Jonathan Davidson Architects Architecture & Industrial Design		Client Capital & Centric		Document Fabric Alterations Ground Floor Strip Out & Alterations	
47 Hilton Street MANCHESTER M1 2EF t: 0161 711 0835 e: inbox@jddavidsonarchitects.com w: www.jddavidsonarchitects.com		Project Neptune Mill Chapelton St, Manchester		Status For information	
Scale 1:100 @ A3		Date Oct 2020		Doc Ref	
				<div>353</div> <div>CD</div> <div>2001</div> <div>T1</div>

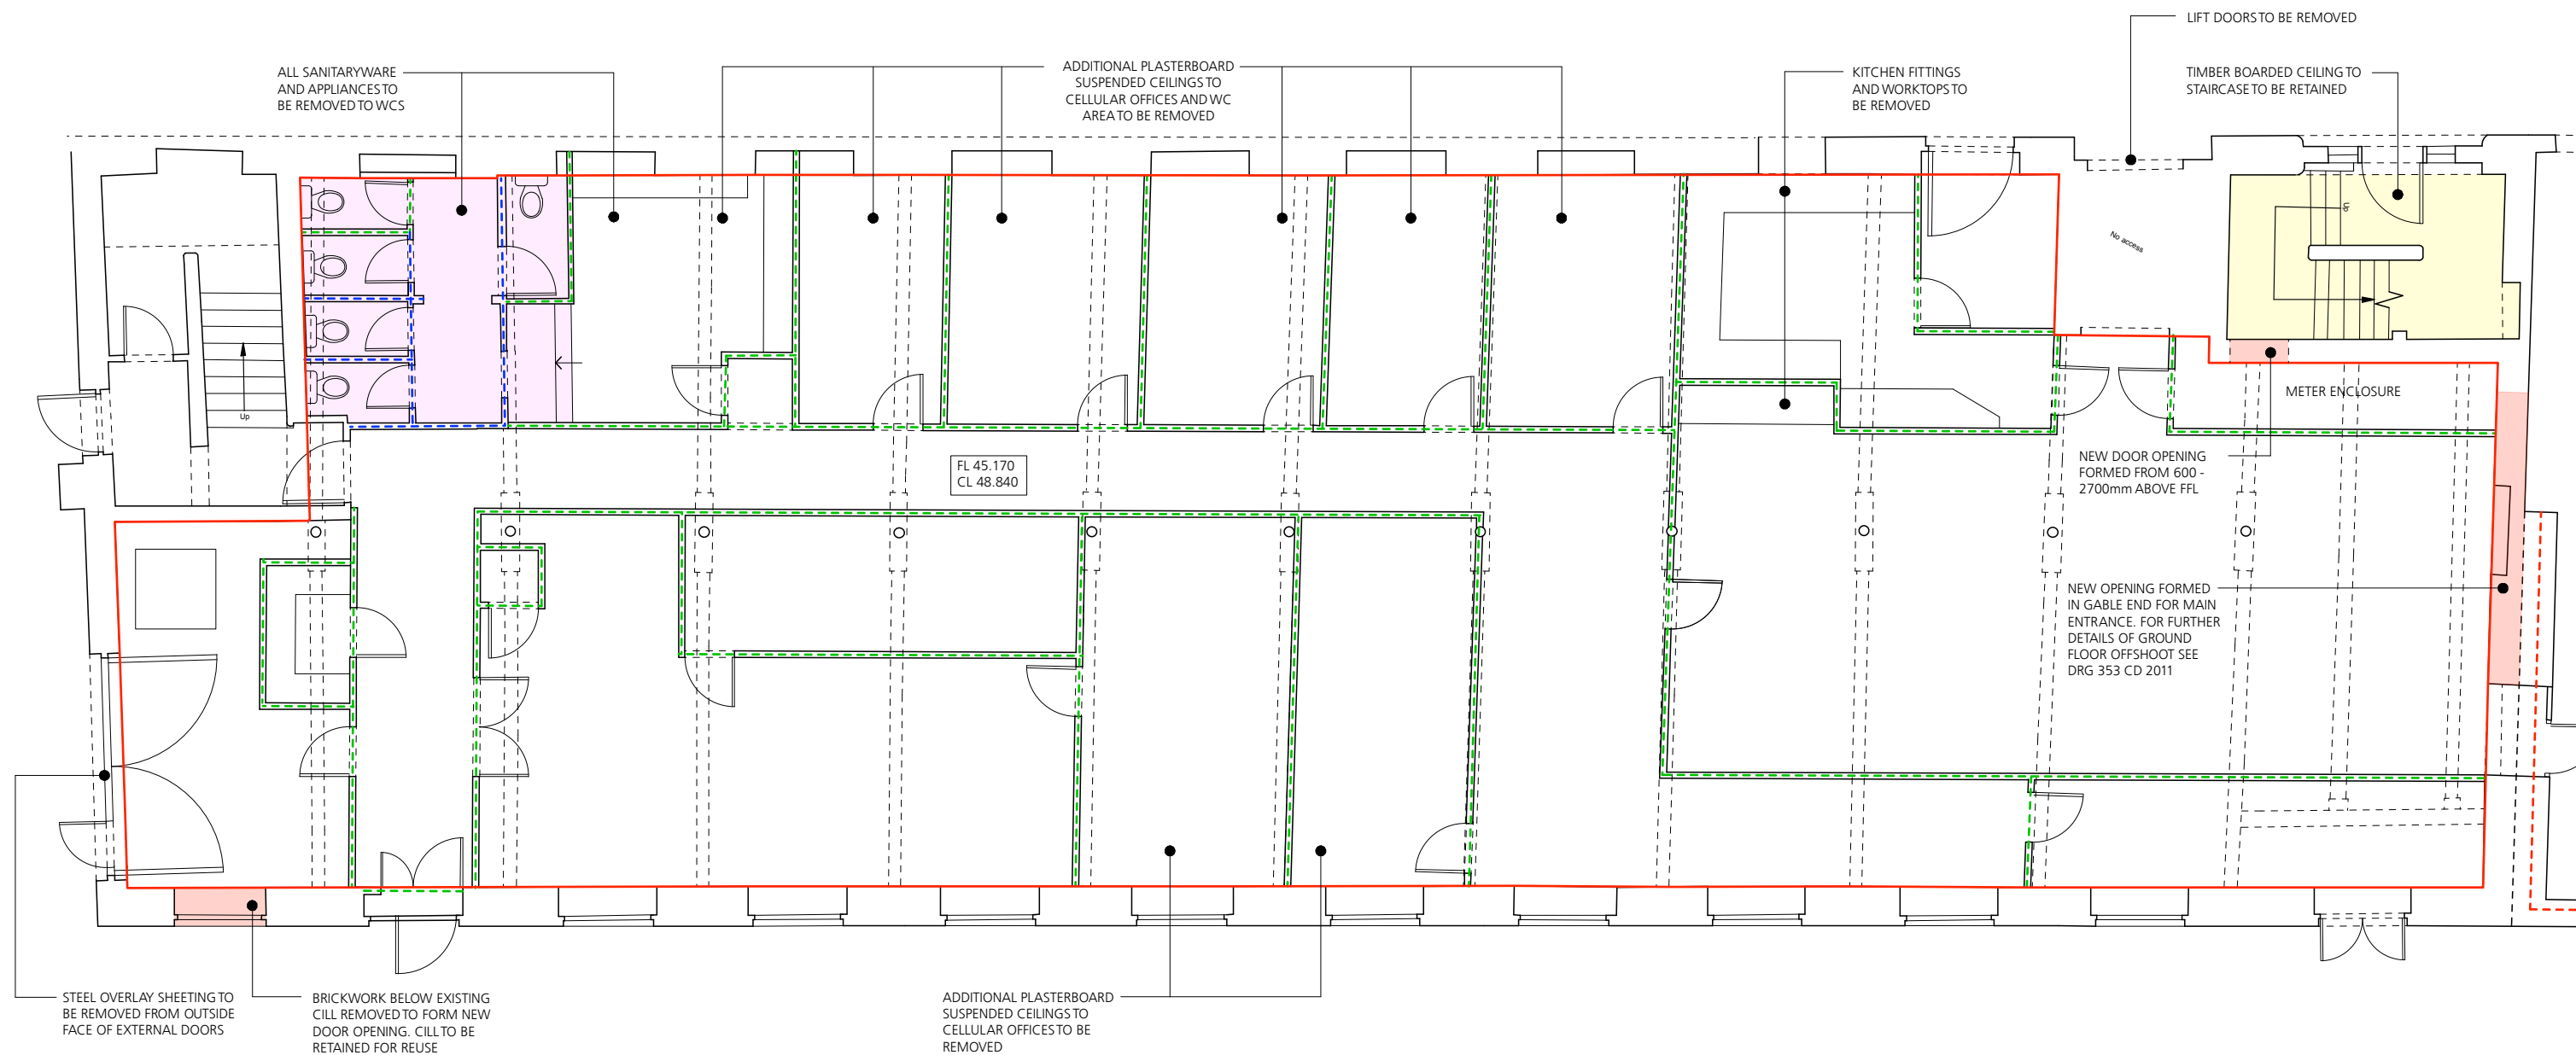
Rev T1 - 11/23 - New door opening to Baird Street relocated to end bay, new opening within west stair omitted, main entrance opening width reduced
